GRANTS LITHIUM PROJECT

Environmental Impact Statement

Supplement

Figure 2-3. Sensitive vegetation communities near the project area

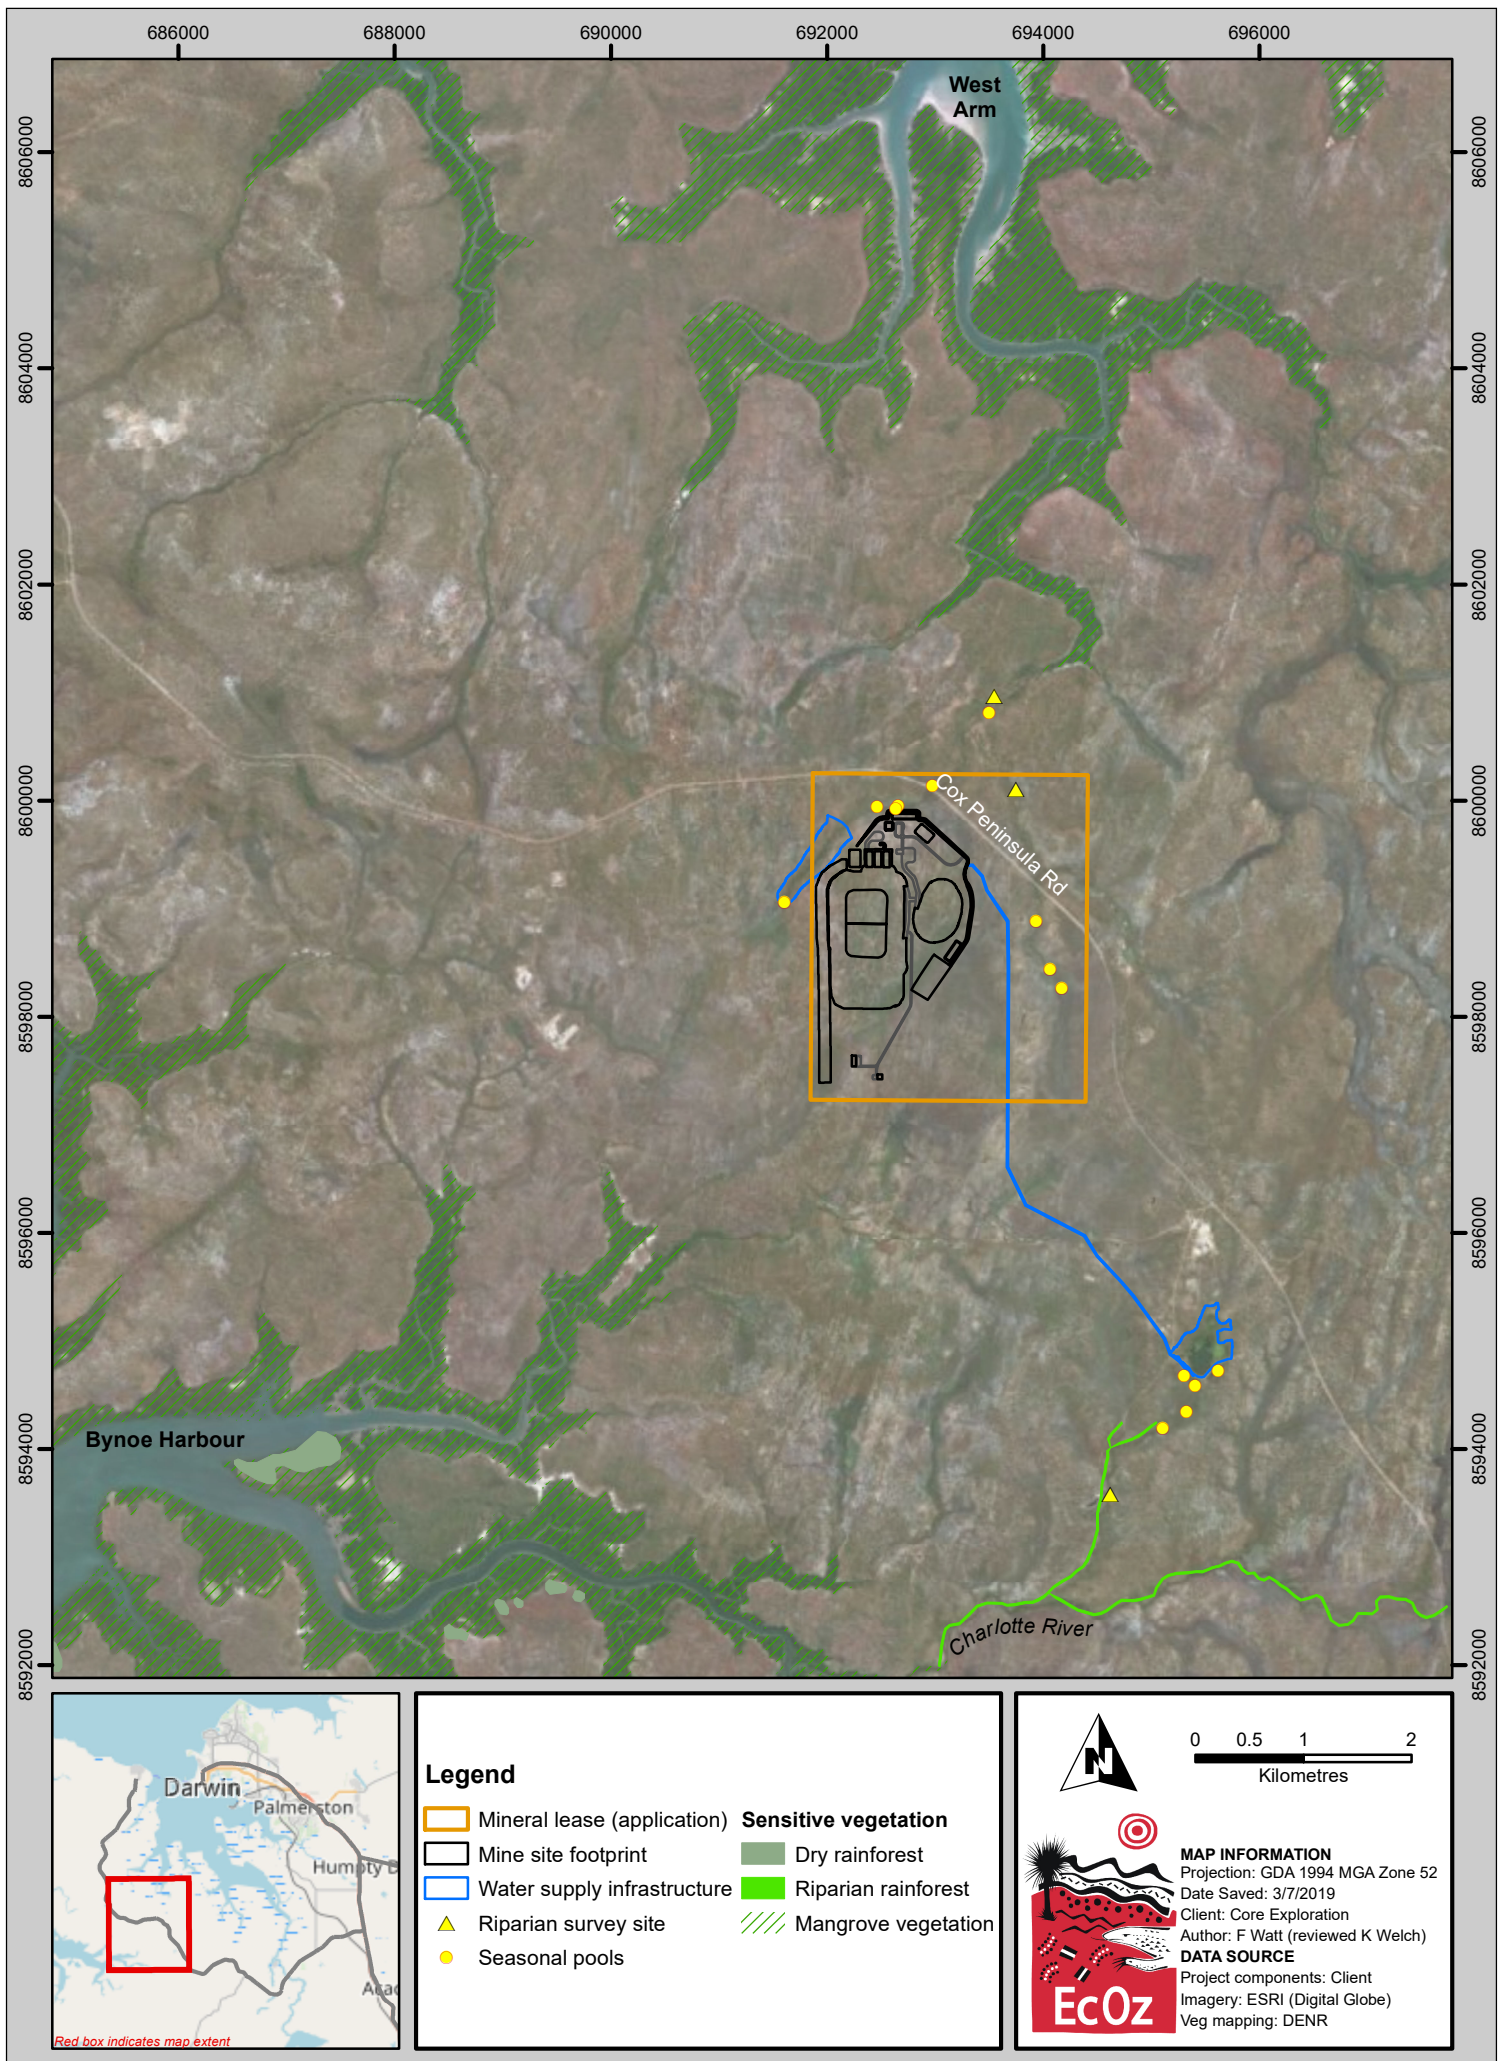
Comment ID:	DENR 3	Topic:	Flora and Fauna	EIS Section:	Chapter 5
Comment					
<p>Riparian habitats and wetlands have been identified on site. However, some of this vegetation or habitat has been excluded from the map of sensitive/significant vegetation provided at Figure 5-6 of the draft EIS. Site layout plans for the proposal indicate that infrastructure will be located within some of these identified habitats. Generally, clearing of these areas should be avoided and buffers of native vegetation retained in accordance with the values associated with the feature being excluded, however, the Flora and Fauna Division acknowledges that where the intended mineral resource overlaps with these habitats, avoidance may not be feasible. While the values of and risks to these sensitive/significant vegetation types are likely to be low, the opportunity to reconfigure infrastructure where practicable to avoid these vegetation types should be investigated.</p>

No sensitive vegetation types will be directly affected; however, there are some small seasonal pools in the broad drainage area that are very close to the northern most edge of the disturbance footprint (see Figure 2-3). Once the site topographical survey is completed, the opportunity to reconfigure the infrastructure to increase the separation distance from these pools will be considered in the next iteration of the site layout.

Response					
<p>The vegetation communities that occur across the project area are shown in Figure 2-2. These were ground-truthed in the field by EcOz (refer Appendix P of Draft EIS submission). Within the ML there is one occurrence of riparian vegetation, which is along the central northern boundary of the ML outside of the disturbance footprint. The location of this patch is shown in Figure 5-6. The drainage line to the north-west of the mine site, that will be dammed to provide the project water supply, is ephemeral and does not support riparian vegetation. The area does; however, support some small seasonal pools (wetlands), the location of which is now shown in the updated map of sensitive vegetation provided in section 2.1.1 (Figure 2-3) of this Supplement.</p> <p>The northern and eastern side of the mine site footprint intersect a broad drainage area, the indicative boundaries of which are shown in Figure 2-2. There are no defined drainage lines/riparian vegetation in this area; however, during the wet season the ground is waterlogged or inundated for extended periods. This broad drainage area also supports some small seasonal pools (wetlands) during the wet season, the location of which are also shown in Figure 2-3.</p> <p>The <i>NT Land Clearing Guidelines</i> recommend broad drainage areas be buffered by 25 m from the outer edge of the seepage zone, but also acknowledge that in certain circumstances these buffers may not be feasible. As much as possible, the mine site infrastructure has been sited within the upland parts of the ML surrounding the Grants pit; however, the inundation bund around the outer edge of the site extends into the upland broad drainage area at some locations. On the eastern side of the project footprint that borders the pit, avoidance of the broad drainage area is not feasible as configuration of infrastructure in this area is constrained by the location of the ore resource. However, following completion of the detailed site topographical survey in March 2019, the opportunity to reconfigure the infrastructure to avoid the broad drainage area and wet season pools that occur on the north-eastern side of the footprint will be considered.</p>
